Item Name: Heli-Utility-Basket™ (Fits LH or RH)

Draw Nbr	Revision Nbr
D350-607-1	A
DSI9709	A

- 2.1 Sheet 2 of this DSI amends Figures 2 of D350-607-1 Rev. A and 25-1 of ICA-D350-607 Rev. 6;
- 2.2 Sheet 3 of this DSI amends Figures 3 of D350-607-1 Rev. A and 25-2 of ICA-D350-607 Rev. 6;
- 2.3 Sheet 4 of this DSI amends the Parts Lists of Installation Instructions D350-607-1 Rev. A (Sections 6.1 and 6.2) and ICA-D350-607 Rev. 6 (Sections 25.27.1 and 25.27.2).

SECTION A-A FRONT TUBE

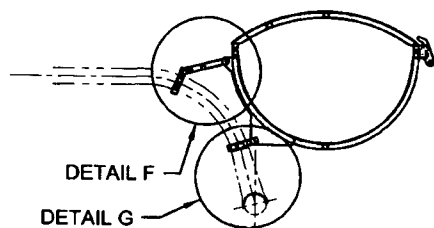
IS: AN4-15A BOLT
WAS: AN4-12A BOLT
